**Amendments to the
Cascade Station/Portland
International Center Plan District**
Amendments to Title 33, Planning and Zoning

Ordinance No. 179076
Adopted February 17, 2005

**City of Portland
Bureau of Planning
1900 SW Fourth Avenue, Suite 4100
Portland, Oregon 97201-5350**

Figure 508-1
Park Blocks and Build-To-Line Area

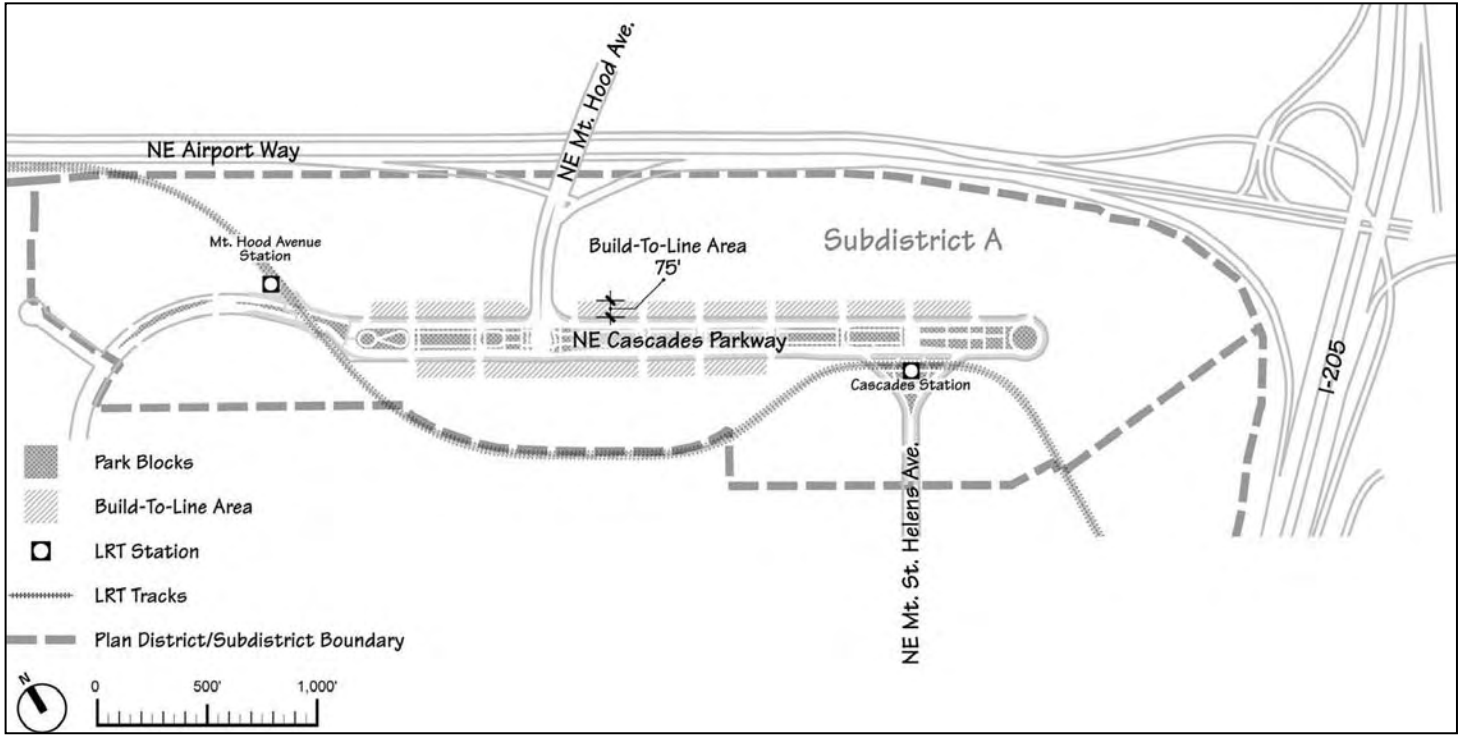
Figure 508-1 is replaced with a new figure with the following changes:

- Expand to include all of Subdistrict A
- Revise the Build-to-Line Area (BLTA) to remove it from the "U shaped" eastern end
- Change depth of BTLA area to match depth referenced in text (75'),
- Remove the former "triangle lot areas" so they no longer need a special exemption
- Base the illustration on the Park Blocks as they were actually constructed
- Improve and standardize the features of the illustration with other Title 33 figures.

Replace Figure 508-1 with updated Figure 508-1 shown below

Figure 508-3
Build-To-Line Setback Exception Illustration

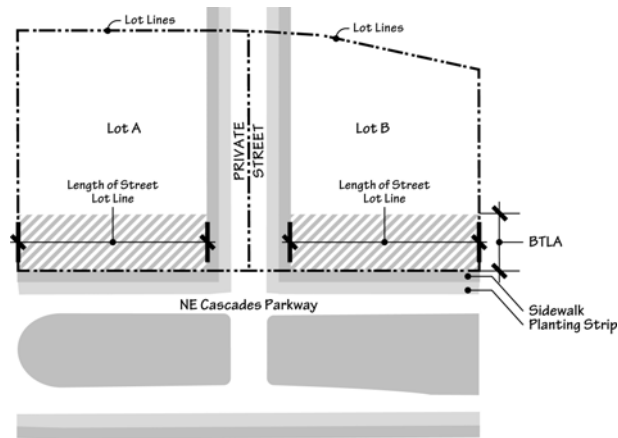
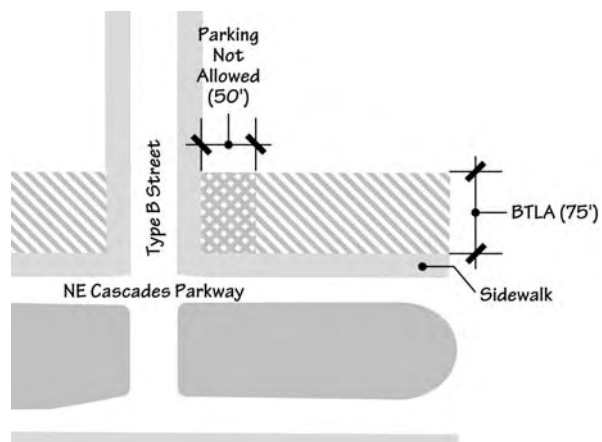
The developers requested reconsideration of the setback standard as requiring buildings on all corner lots constrains desired design flexibility and presents problems in creating a varied and interesting pedestrian environment. The new language for 230.D.1.c (3) and (4) provides some flexibility because where a lot fronts on both Cascades Parkway and a Type A, C, or D street, the buildings must come up to both frontages. However, where a lot fronts on both Cascades Parkway and a Type B street, the maximum setback only applies along Cascades; the side street is exempt. A new figure 508-3 illustrates this concept.

A clarified figure 508-2 and new illustrative figure 508-3 correspond to new setback language for the Build-to-Line area provision.

- (4) Exception. Buildings with street lot line frontage on both NE Cascades Parkway and a Type B street must meet the standards of D.1.c.(1) and (2) on the NE Cascades Parkway street lot line frontage, but do not have to meet the standards on the Type B street lot line frontage. However, surface parking is not allowed within 50 feet of the street lot line frontage on the Type B street within the BTLA. See Figure 508-3.

**Figure 508-34
Building Entrances**

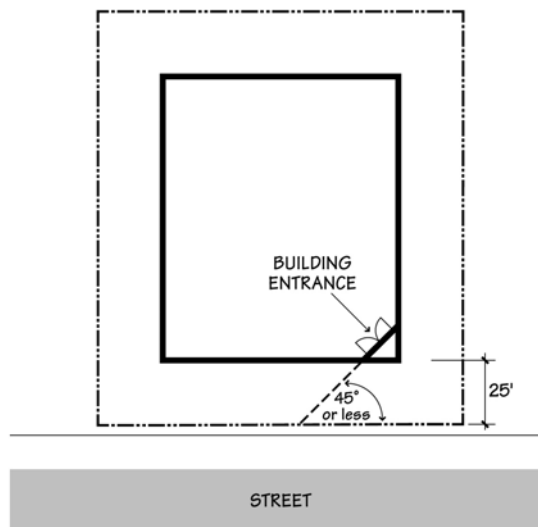
Figure 508-3 replaced with updated Figure 508-4 below

(2) Be at an angle of up to 45 degrees from the street lot line street, measured from the street lot line, as shown in Figure 508-4; or

Figure 508-5
Cascades Station Area

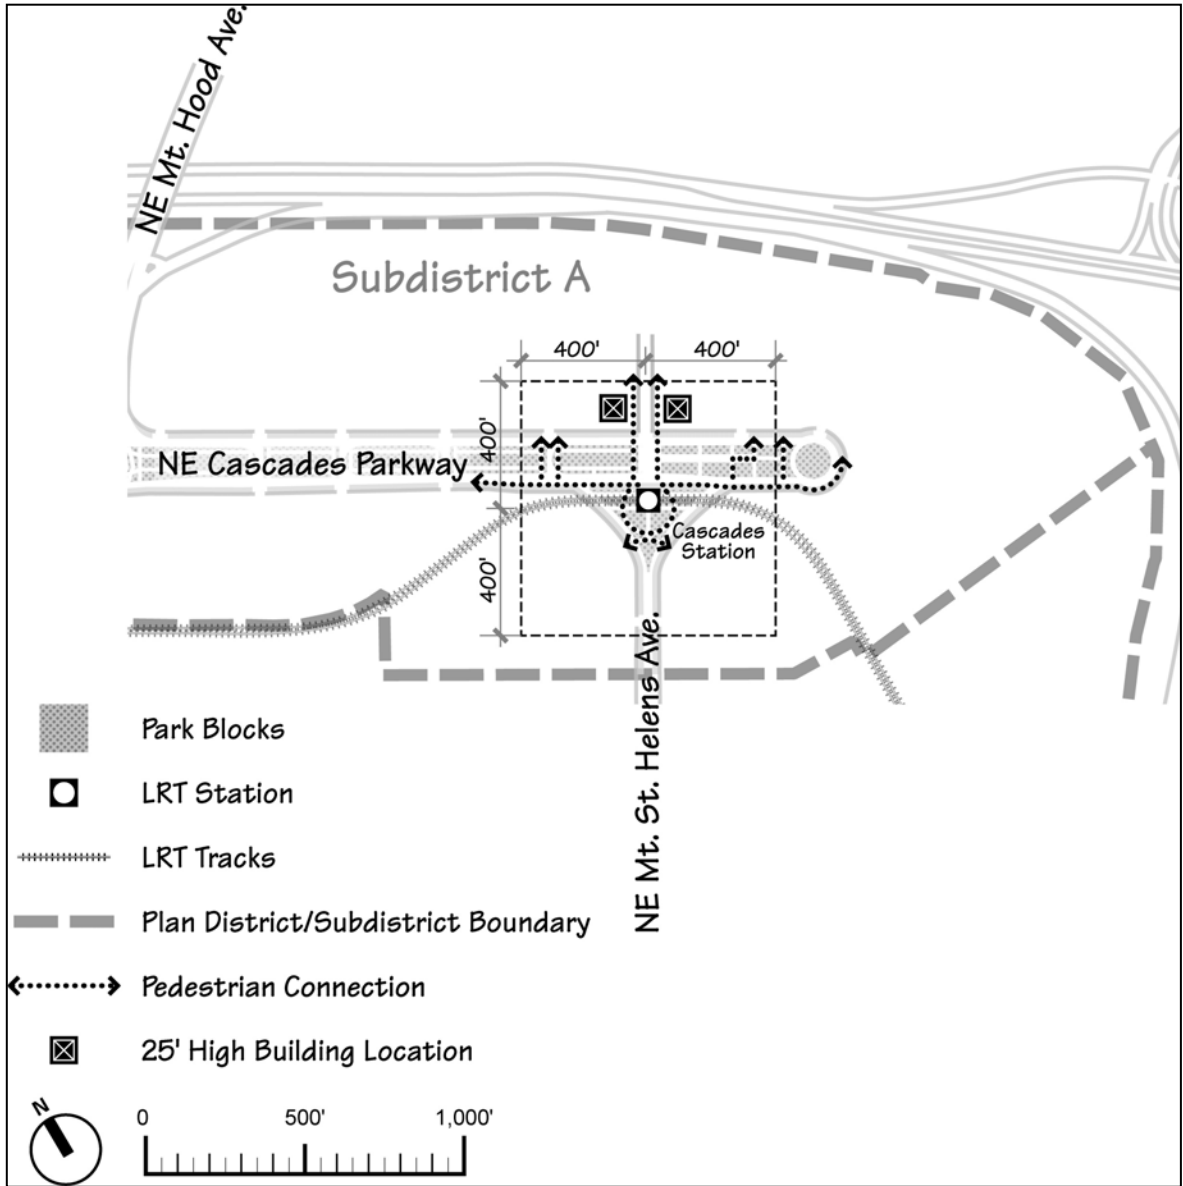
Figure 508-2 replaced with updated Figure 508-5 below

E. **Within Cascades Station Area.** All development within the ~~East Cascades~~ Station Area, shown on Figure 508-5, must meet the regulations of this Subsection.

Figure 508-6
Mt. Hood Station Area

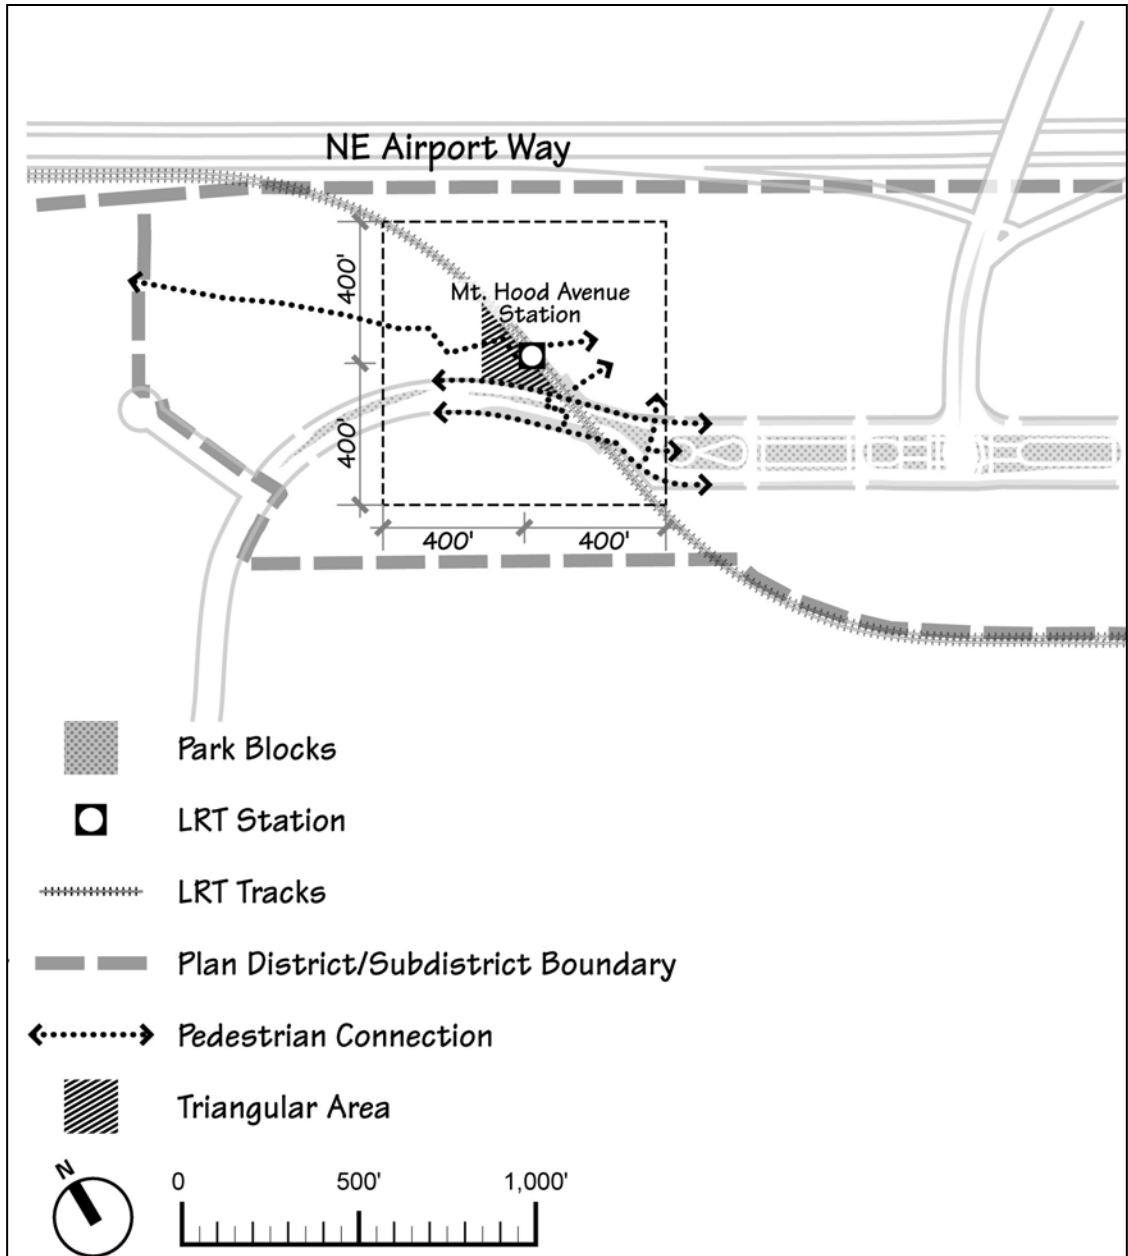
Given the emphasis on station areas in lieu of emphasizing the entire BTLA, this section is added to create standards for the Mt. Hood Station Area that parallel those that apply to the Cascades Station Area. There is a new Figure 508-6 that shows the area included under this provision. These standards are supplemented by provisions for master planning and design elements in the PDC Development Agreement.

F. Within Mt. Hood Station Area. All development within the Mt. Hood Station Area, shown on Figure 508-6, must meet the regulations of this Subsection.

2. Pedestrian connections. Pedestrian connections from the light rail platform must provide for pedestrian movements to the Park Block pedestrian network, to the lots to the south across NE Cascades Parkway. The connections must be in the general location shown on Figure 508-6.

Figure 508-7
Basic Public Infrastructure

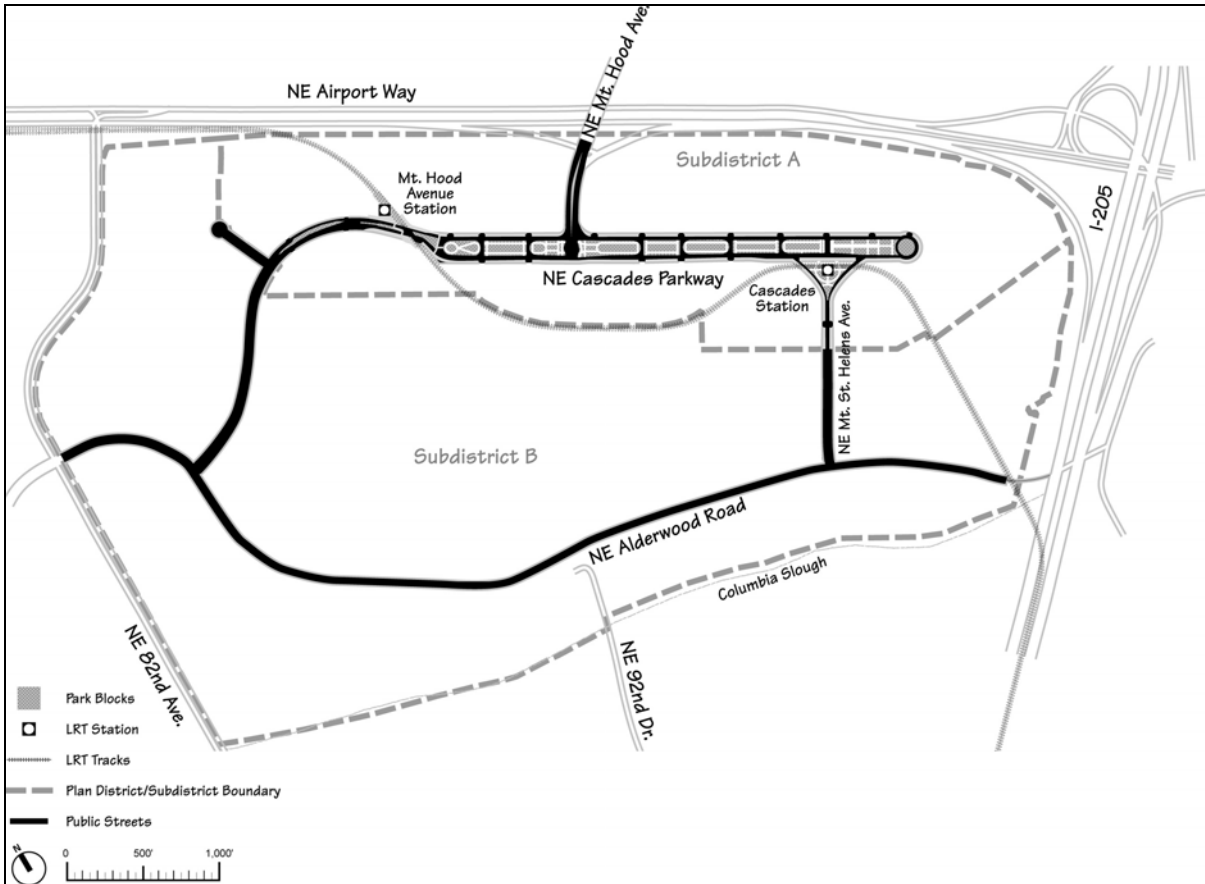
The infrastructure required by this section has already been constructed and the section is recommended for deletion. The existing Figure 508-4 is replaced with a new Figure 508-7.

Replace Figure 508-4 with Figure 508-7 below that does not include East-West "loop street" and two public streets north of NE Cascades Parkway, and move figure to subsection 33.508.280.A

A. Public streets. Public streets are shown on Figure 508-7. Some of these streets have been completed and dedicated.

Figure 508-8
Street Requirements in Subdistrict A

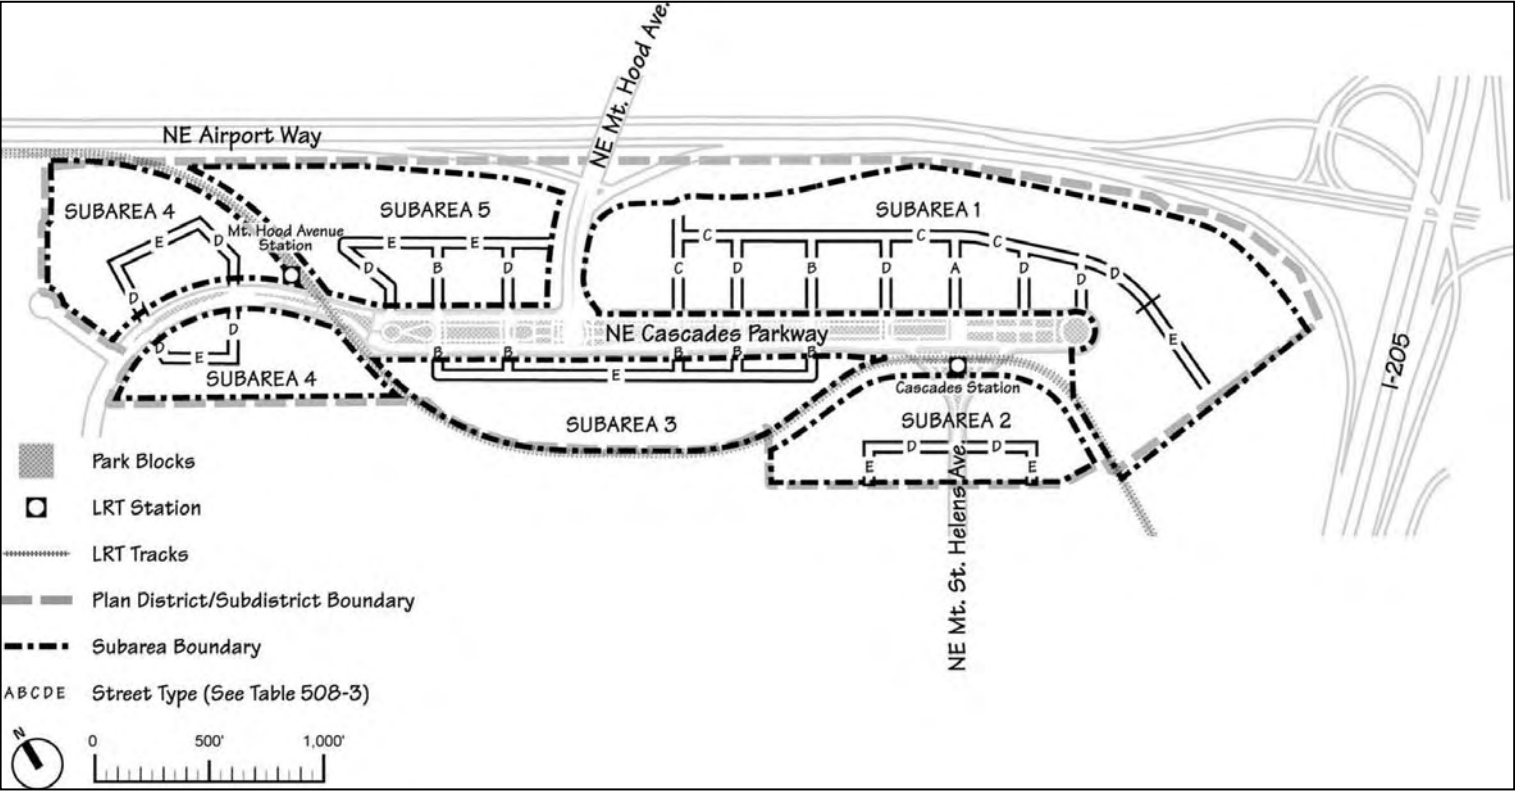
The Street Requirements in Subdistrict A (Figure 508-8) will be used and enforced by BDS and PDOT and also used by the Coordinated Design Review process, as the subareas match up with the required master planning subareas.

Figure 508-5 replaced with updated Figure 508-8 Street Plan shown below

- a. The approximate locations for private streets are shown in the Street Plan, Figure 508-8.
- b. The Portland Office of Transportation and BDS determine the extent and timing of street improvements.
- c. Buildings and other improvements must be located so that they do not preclude creation of streets in conformance with the Section.
- d. All measurements in the Section are from centerline to centerline, unless specified otherwise.

**Figure 508-9
Type A Street**

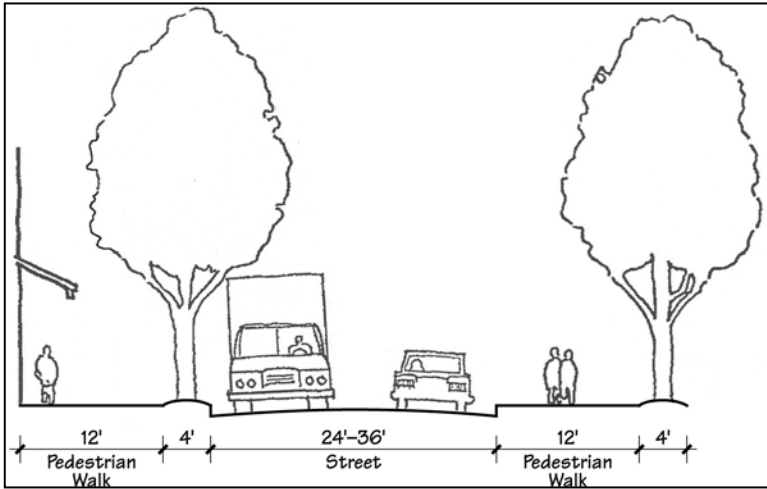
Illustration Figures 508-7 and 508-8 are deleted and replaced with new figures 508-9 and 508-10 as part of the street requirements described in this section and new Figure 508-8 and Table 508-3.

Figure 508-6 replaced with new Figure 508-9 shown below

**Figure 508-10
Type B Street**

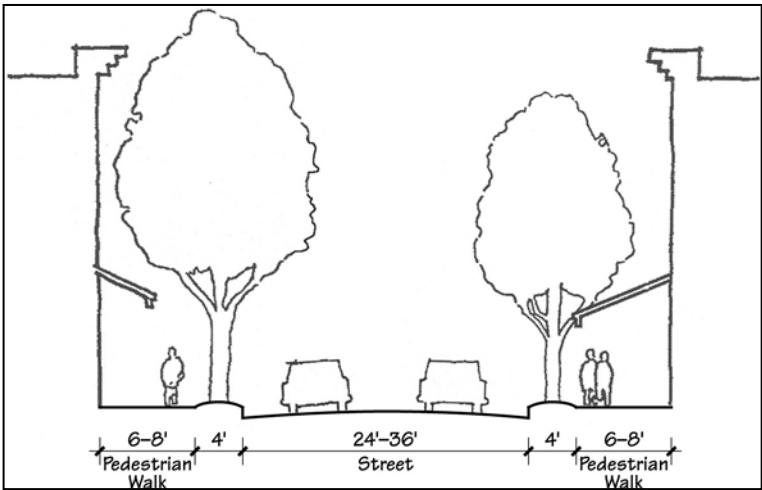
Figure 508-7 replaced with new Figure 508-10 shown below

**Figure 508-11
Type C Street**

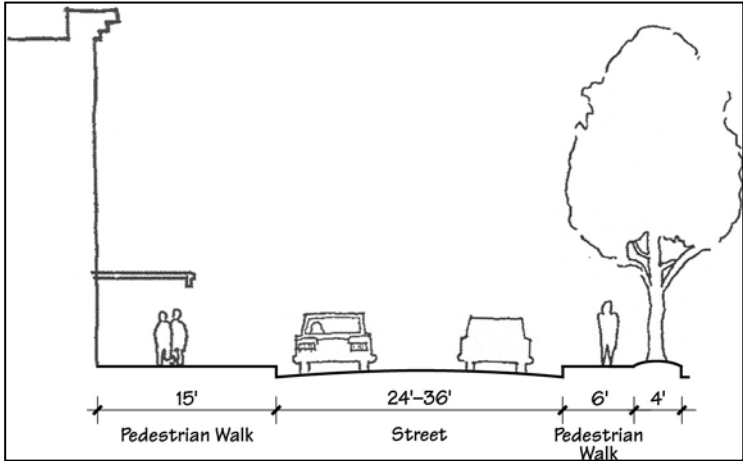
New illustrative Figures 508-11 and 508-12 are added as described in this section and new Figure 508-8 and Table 508-3.

New Figure 508-11 shown below

**Figure 508-12
Type D Street**

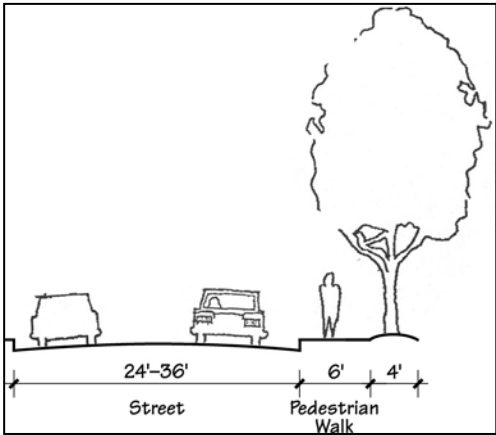
New Figure 508-12 shown below

Figure 508-09~~13~~
Bicycle and Pedestrian Circulation Plan

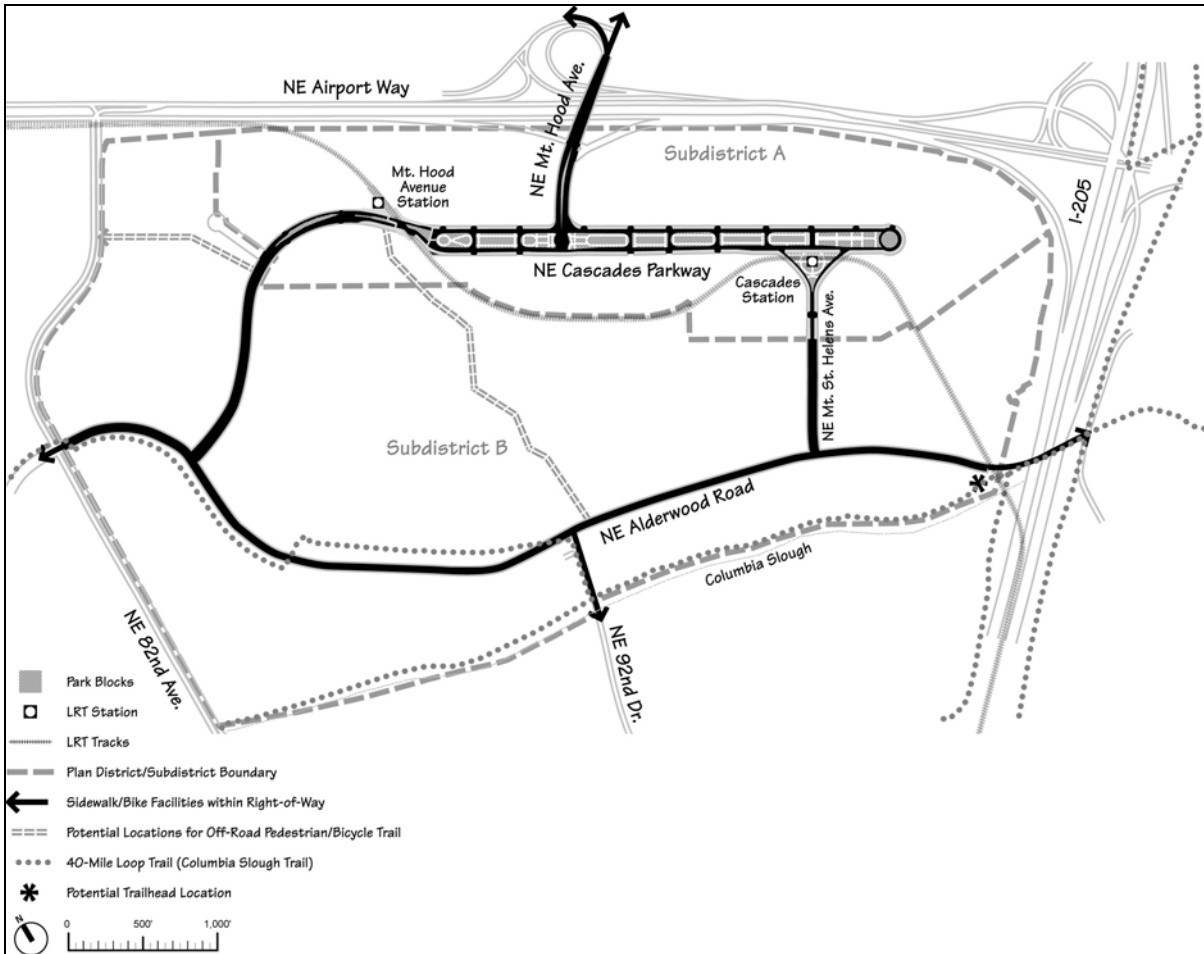
It is appropriate for the proposed trail connection from the south to the Mount Hood Station Area as depicted in Figure 508-13 be built when the area south of the station area develops.

Figure 508-09 replaced with updated Figure 508-13 shown below
